RESPONSES TO
NRC QUESTIONS
ON THE
MONTICELLO PUAR

PREPARED BY
NUTECH ENGINEERS, INC.
SAN JOSE, CALIFORNIA

PREPARED FOR
NORTHERN STATES POWER CO.

NRC QUESTION ON MONTICELLO PUAR
HYDRODYNAMIC LOAD RESPONSE

Figure 11 - 4"φ

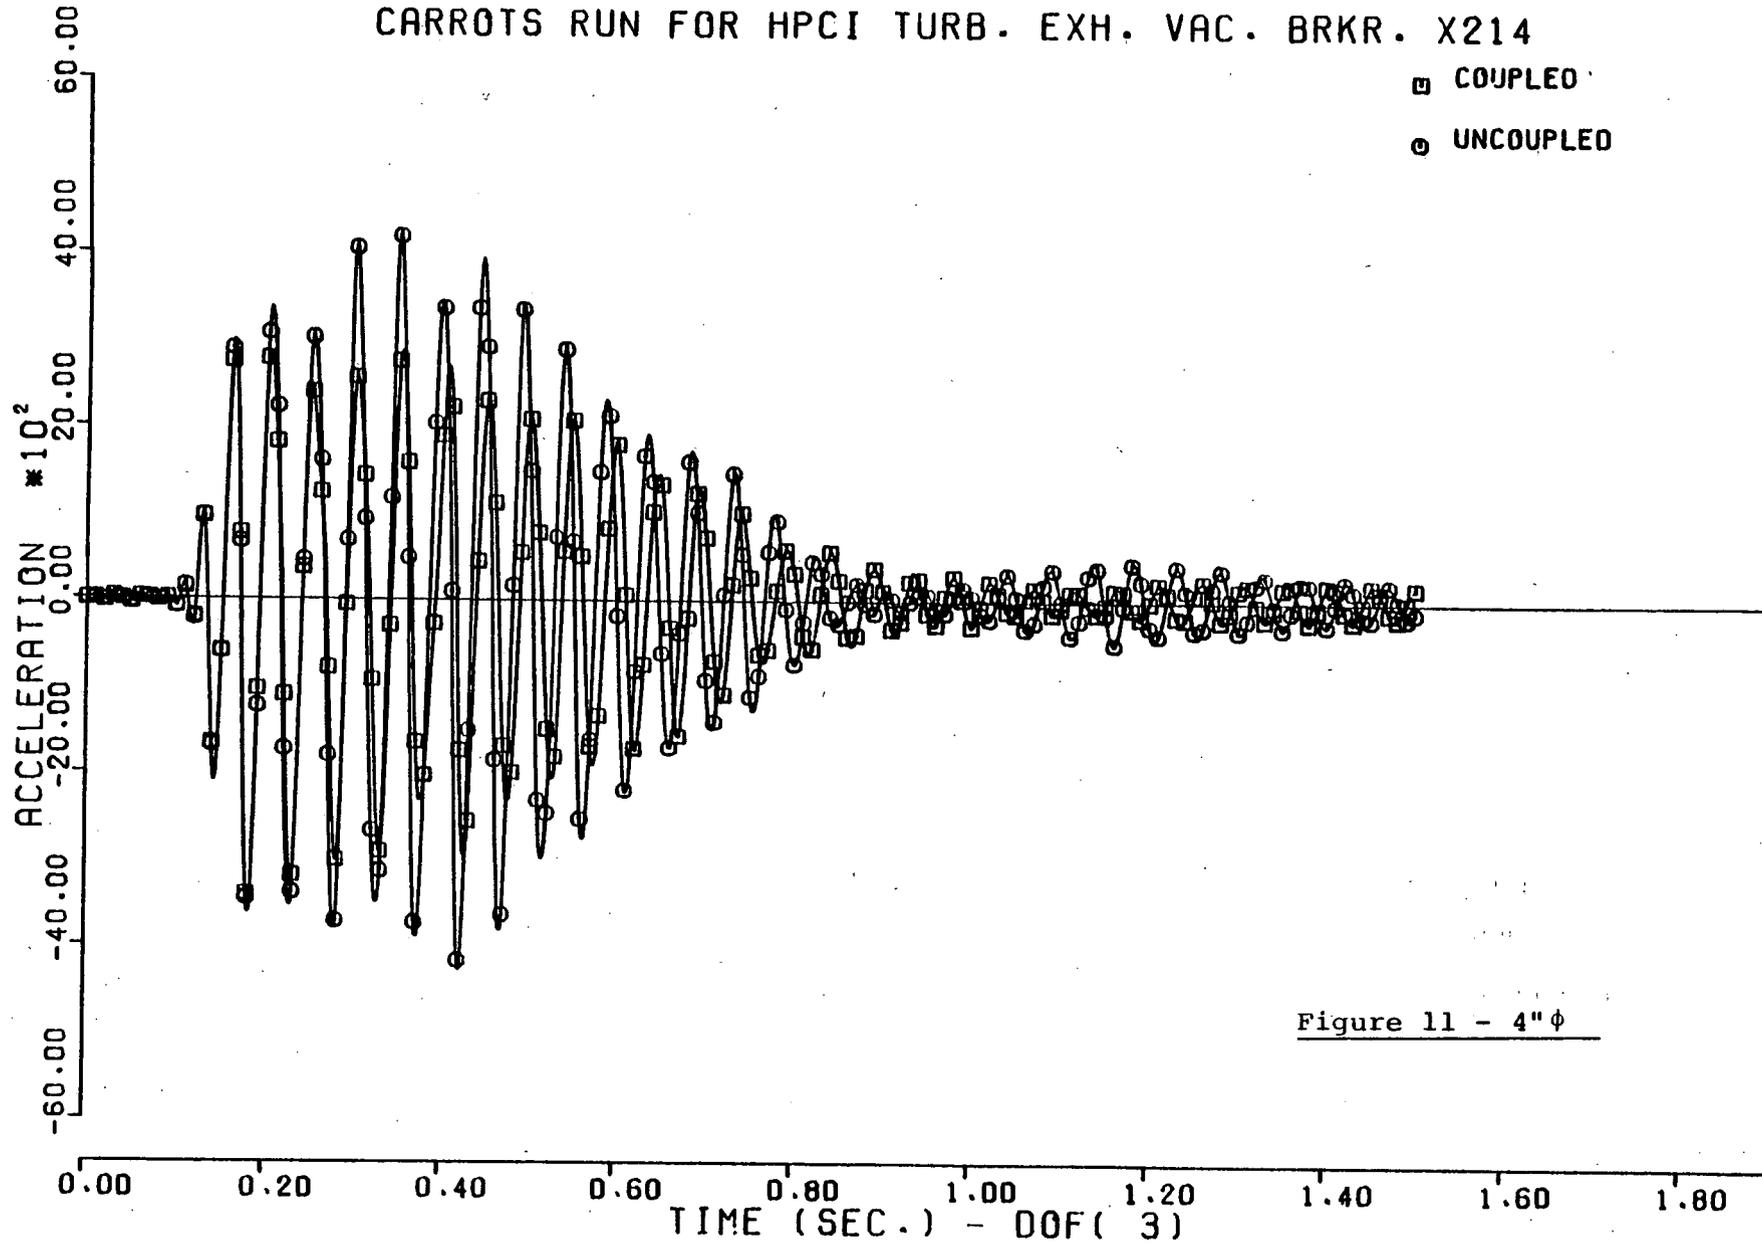
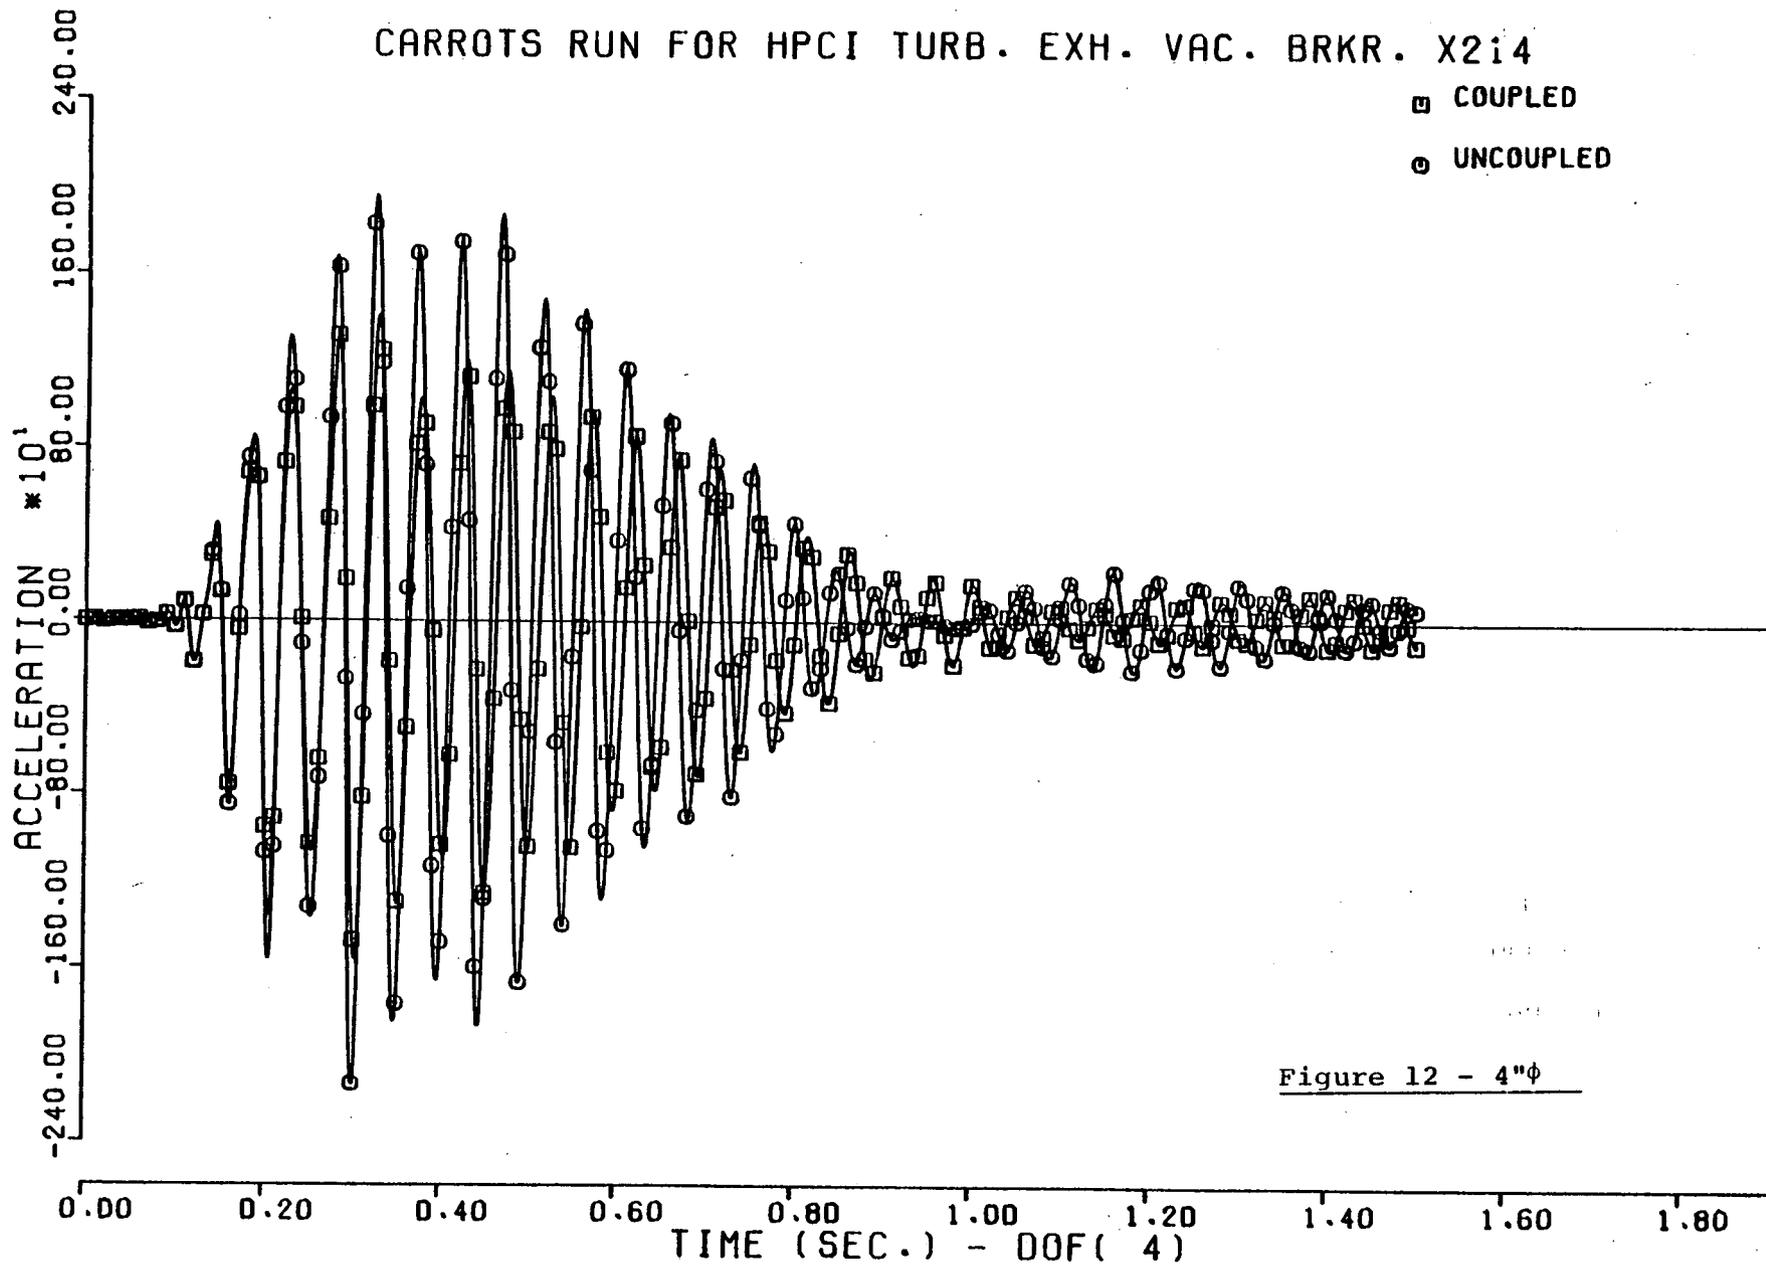
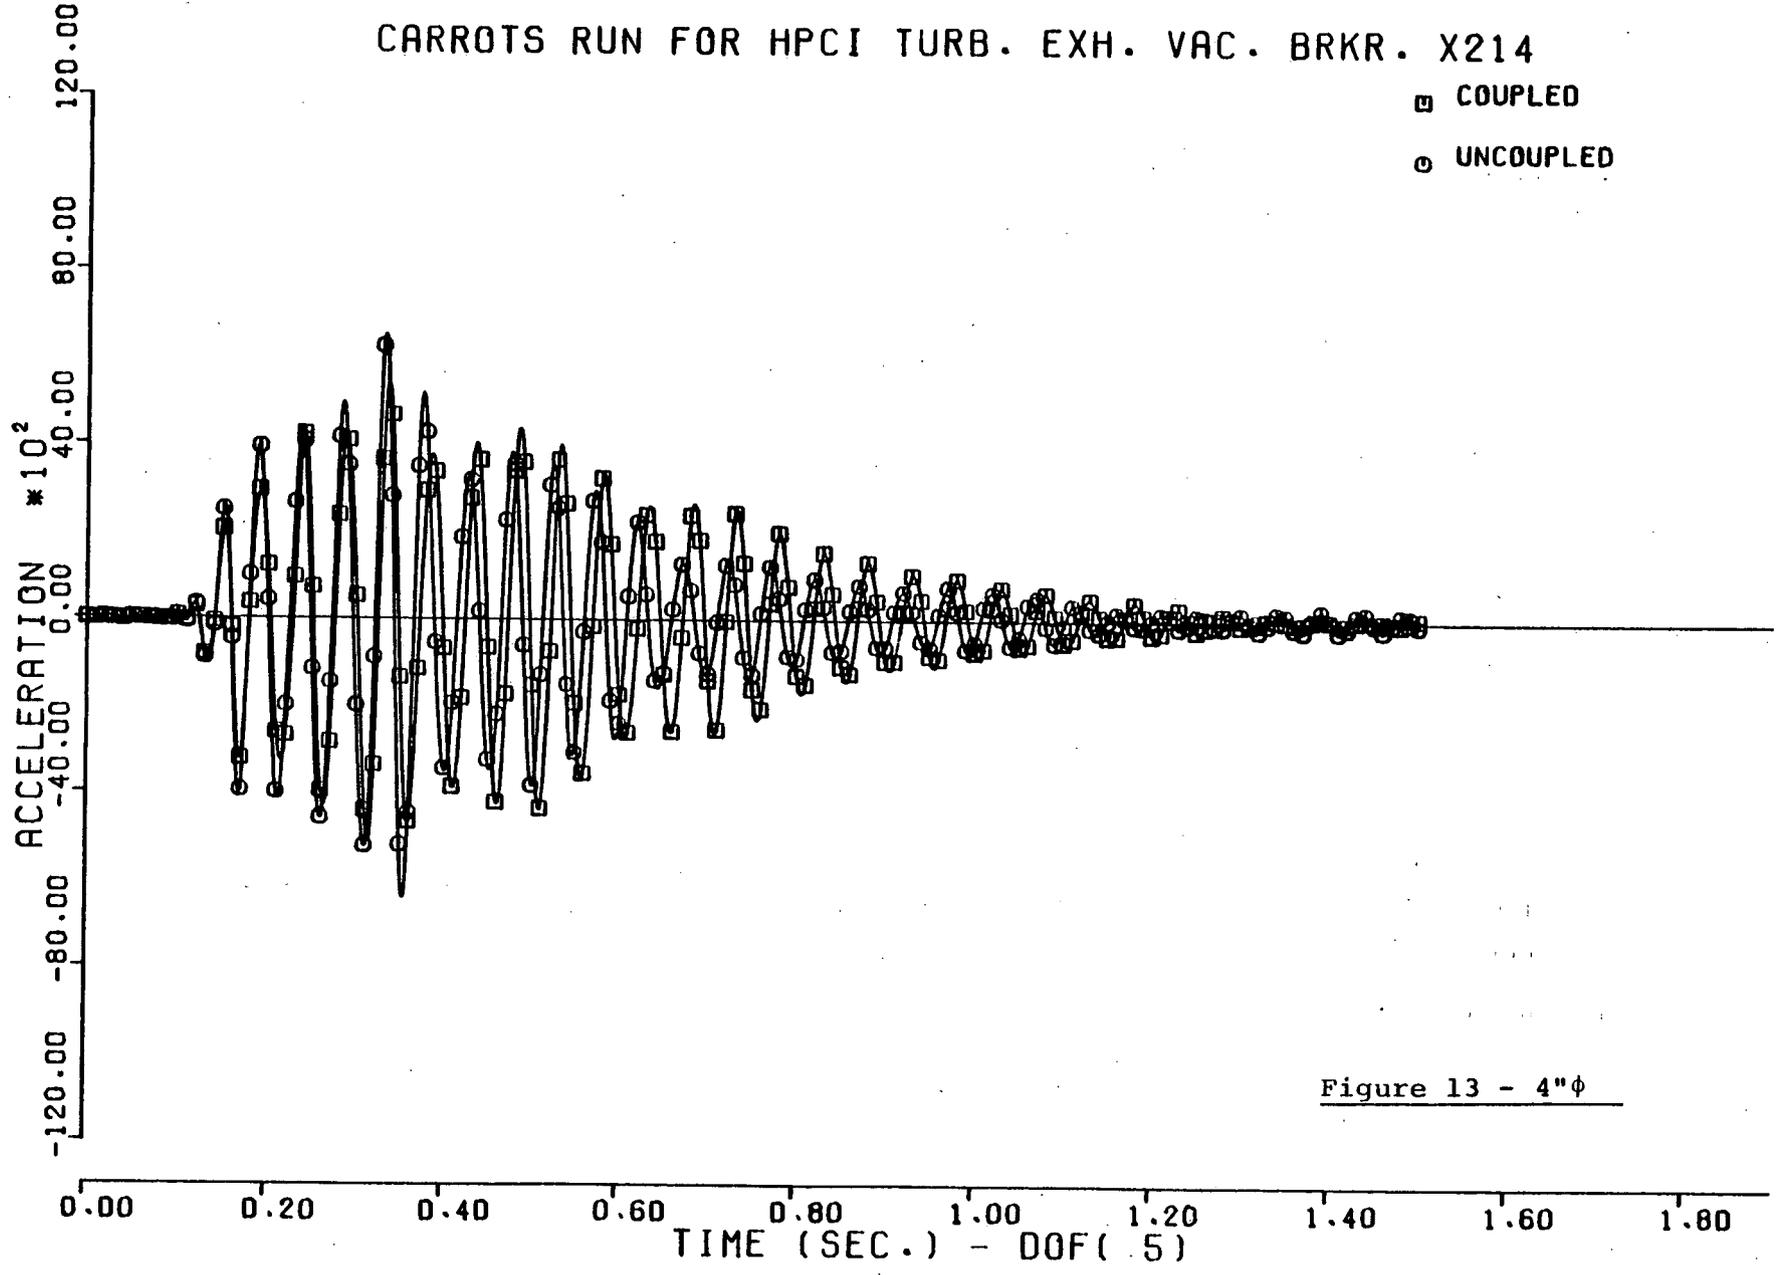
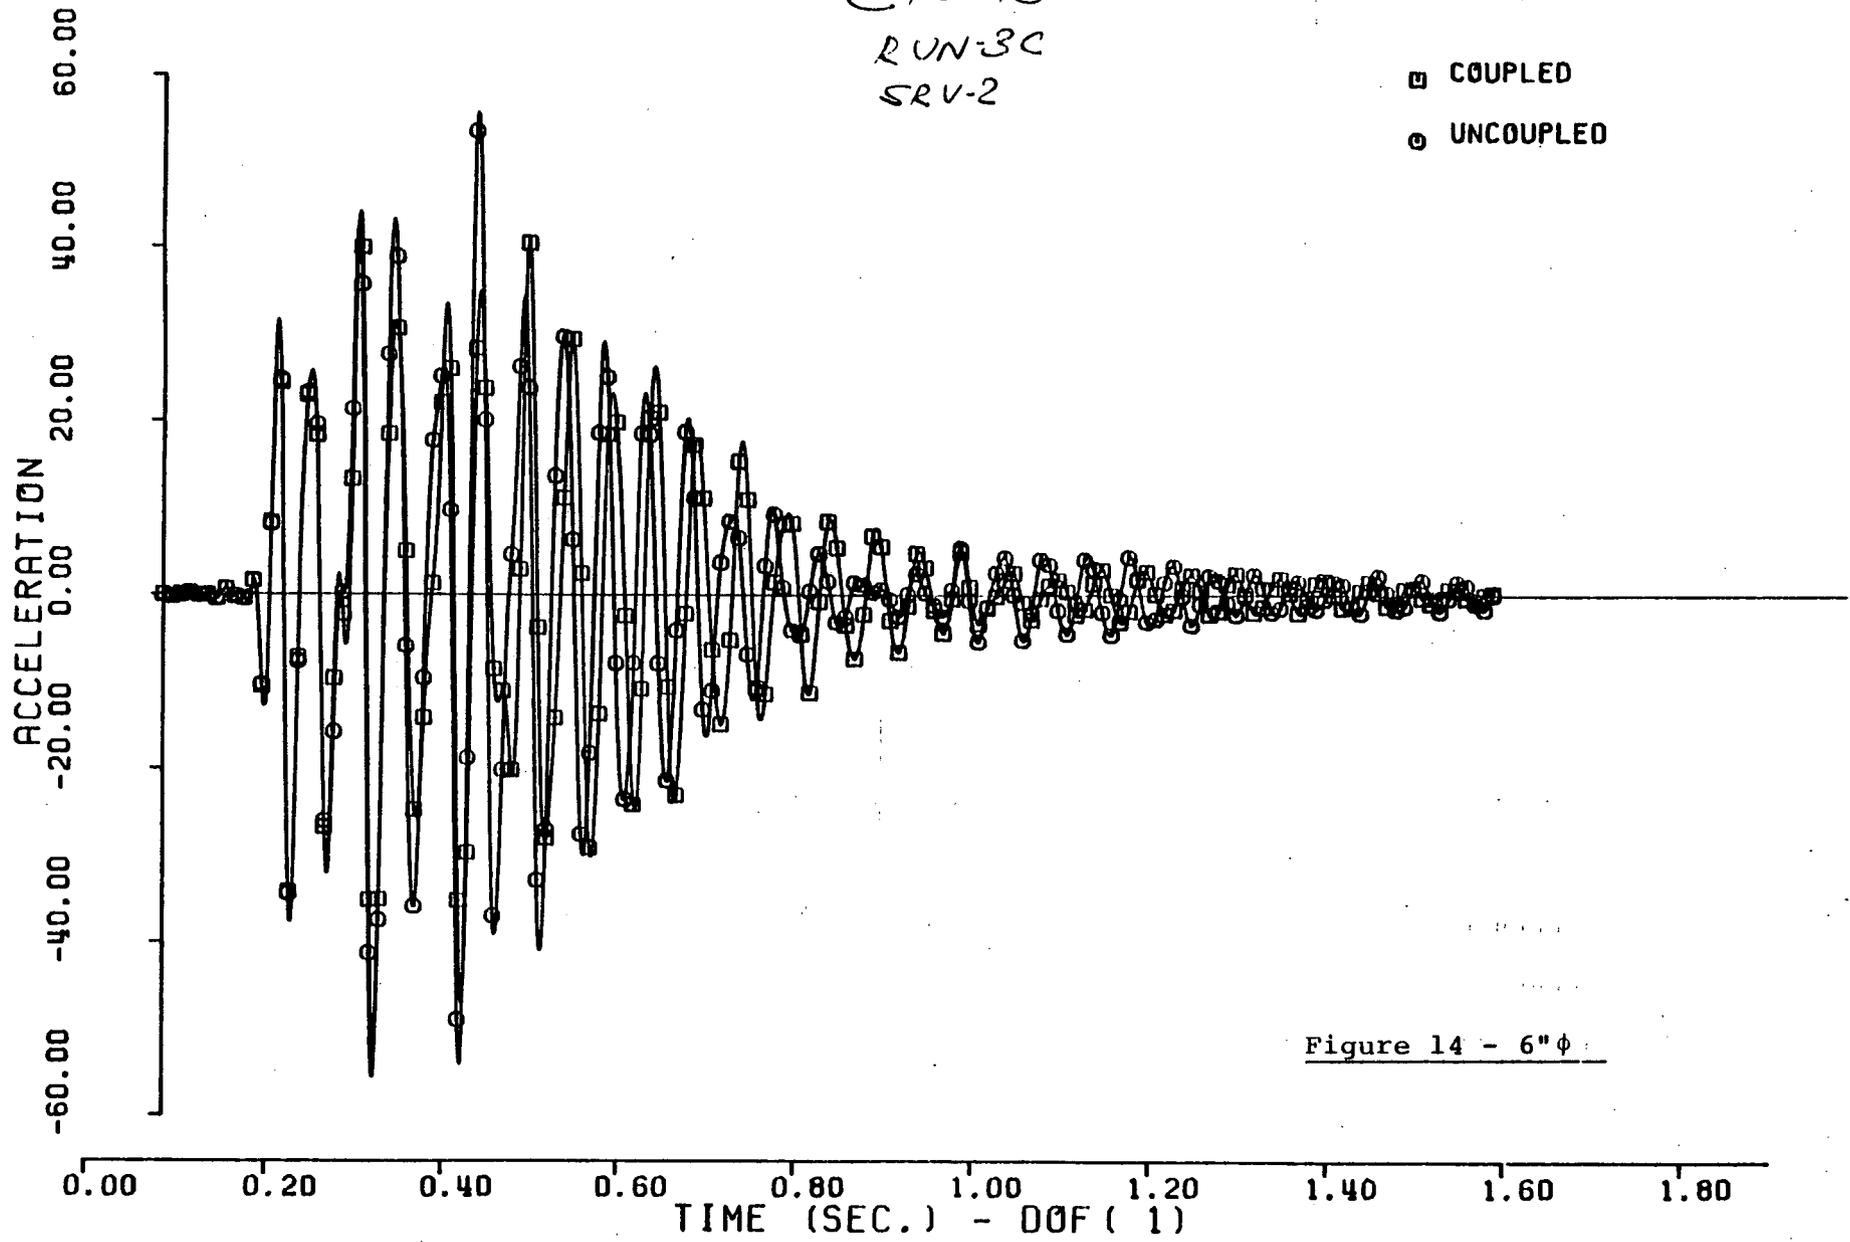
ITEM 12: The computer code CMDOF has been used in the torus attached piping analysis for all plants that utilized NUTECH as their contractor. With regard to the code provide the following information:

- 1) Theoretical background of CMDOF computer program
- 2) Program verification
- 3) Applicability of the computer program to the torus attached piping analysis.

To illustrate the effect of pipe size on coupling, four typical piping systems were examined and the coupled and uncoupled time histories plotted together. These time histories include both the smallest (2") and larger (20") systems analyzed. Listed below are the figure numbers and the corresponding line size.

Figure 4-8	2" diameter
9-13	4" diameter
14-18	6" diameter
19-21	20" diameter

These plots confirm the expected variation of coupling benefit with pipe size.
